Item ID: D412-664-203TRN Accept *N900040100* Setup Start *NS1*
 Revision ID: Stop *NS2*
 Item Name: Crosstube Turning Detail
 Start Date: 2/28/14 Start Qty: 1.00 *1* Cust Item ID:
 Required Date: 3/14/14 Req'd Qty: 1.00 *1* Customer:
 Reference:

DART AEROSPACE LTD		Work Order:	113974
Description: Crosstube Assembly (412 High Aft)		Part Number:	D412-664-243
Inspection Dwg: D412-664-243 Rev: E		Page 1 of 2

DRAWING NO. D412-664-243	TITLE CROSSTUBE ASSEMBLY (412 HI AFT)	REV. E	DART AEROSPACE LTD ENGINEERING ORDER	D.E.O. NO. D412-664-243-E-4	SHEET NO. SHEET 1 OF 3	SCALE NTS
DRAWN <i>JP</i>	CHECKED <i>A</i>	MFG. APPR. <i>A</i>	APPROVED <i>JP</i>	DE APPR. <i>JP</i>		
DATE 12.08.21	DATE 12.08.30	DATE 12.08.30	DATE 12/8/30	DATE 12.08.30

D412-664-603
BENT TUBE

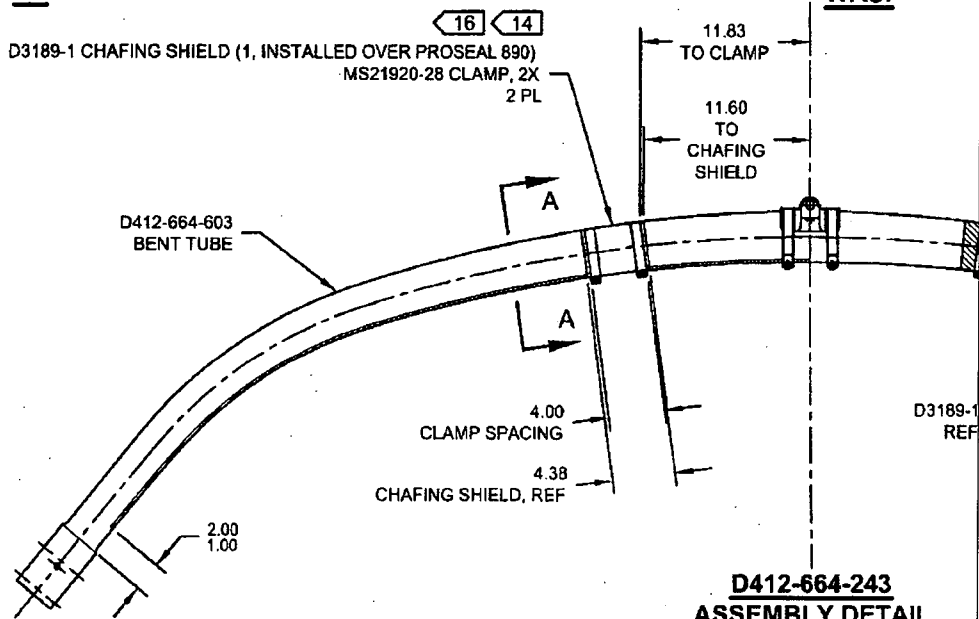
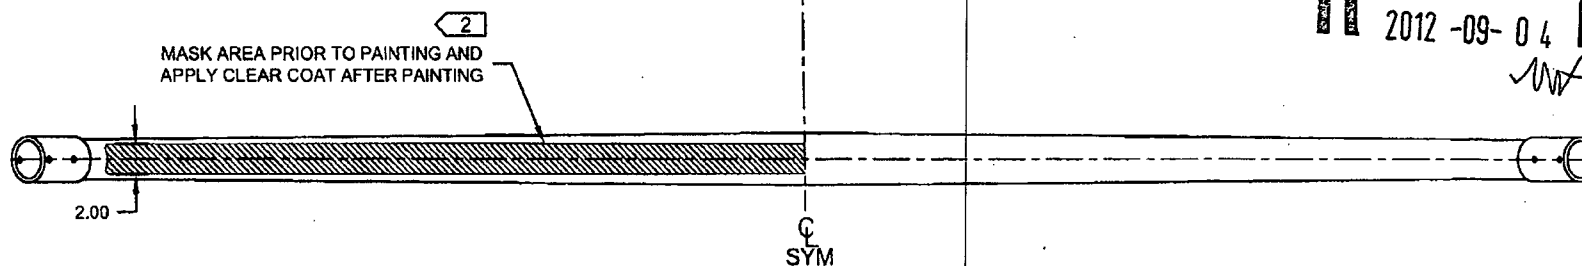
REMOVED ABRASION STRIP IN FAVOR OF A THIN LAYER OF PROSEAL 890. UPDATE INSTALLATION OF CHAFING SHIELDS AND REDUCE TORQUE TO 40-50 IN-LBS. THIS ENGINEERING ORDER SUPERCEDES DEO D412-664-243-E-1.

D3189-1 CHAFING SHIELD (1, INSTALLED OVER PROSEAL 890)
MS21920-28 CLAMP, 2X
2 PL

D2856-600-1009 ABRASION STRIP
D3189-1 CHAFING SHIELD (1, INSTALLED OVER ABRASION STRIP)
MS21920-28 CLAMP, 2X
2 PL

SECTION A-A
CHAFING SHIELD DETAIL
VIEW ROTATED, NOT TO SCALE

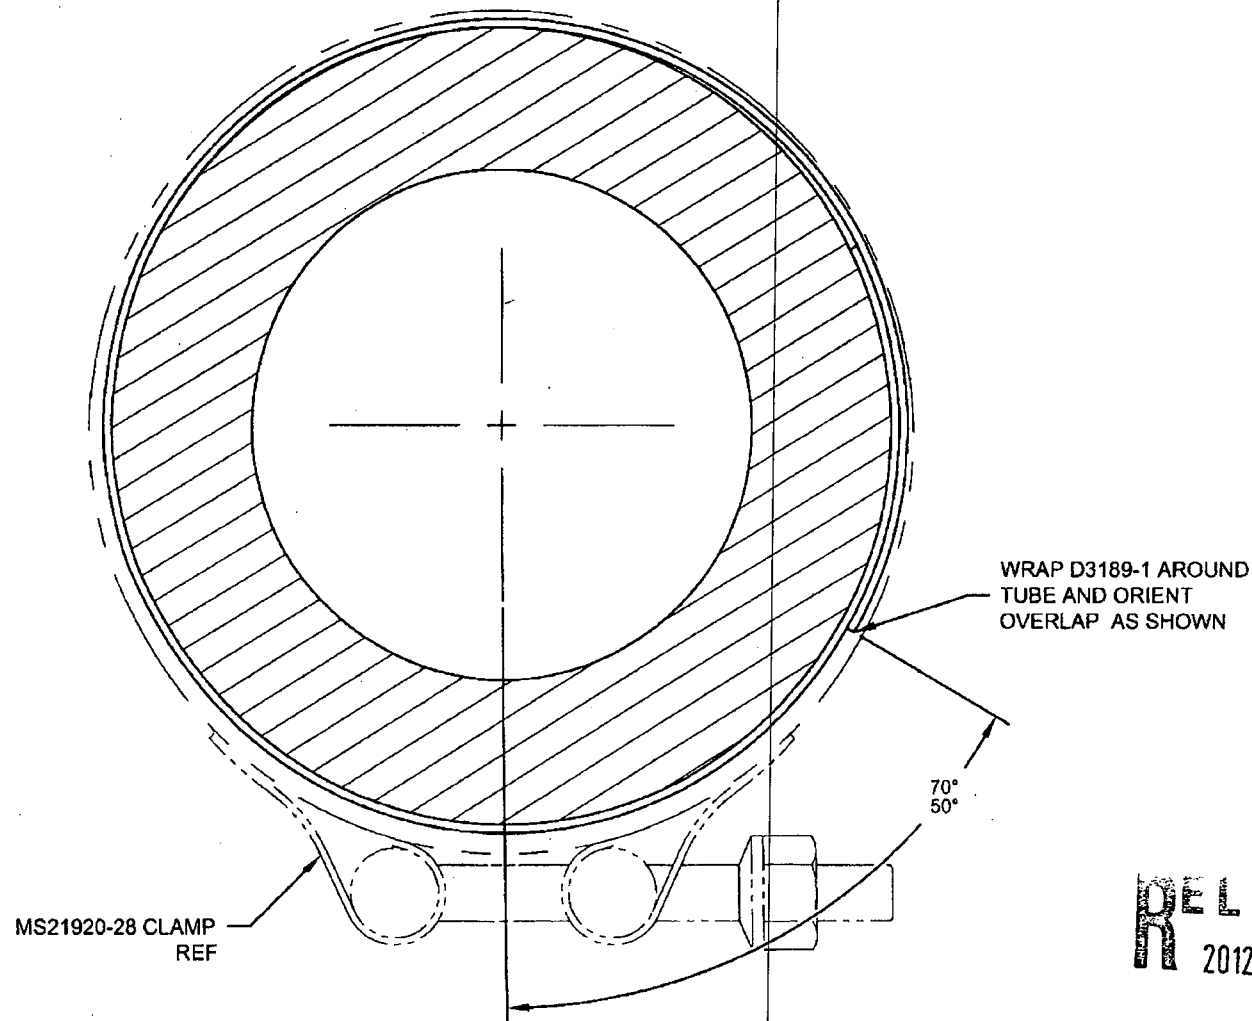
- 2) FINISH: CHEMICAL CONVERSION COAT PER DART QSI 005 4.1
PRIME INSIDE AND OUTSIDE PER DART QSI 005 4.2
MASK UNDERSIDE OF CROSSTUBE AS SHOWN (HATCHED AREA)
PAINT OUTSIDE PER DART QSI 005 4.2
AFTER PAINTING, APPLY CLEAR COAT ON HATCHED AREA
- 14) APPLY A THIN COAT OF PROSEAL 890 ON INSIDE CONCAVE SURFACE OF D3189-1 CHAFING SHIELD AND LET CURE PER MANUFACTURER'S INSTRUCTIONS. INSTALL PROSEALED D3189-1 CHAFING SHIELD ONTO CROSSTUBE BY APPLYING A THIN COAT OF PROSEAL 890 ONTO CROSSTUBE. BE SURE TO ELIMINATE ANY AIR GAPS.
- 16) TORQUE CLAMPS ON D2896-1 SUPPORT 80 TO 100 IN-LB. **TORQUE CLAMPS ON D3189-1 CHAFING SHIELD 40 TO 50 IN-LB.**
ENSURE AT LEAST 1.5 THREADS SHOWING IN SAFETY AND THAT NUT HAS NOT BOTTOMED-OUT AFTER TORQUING.
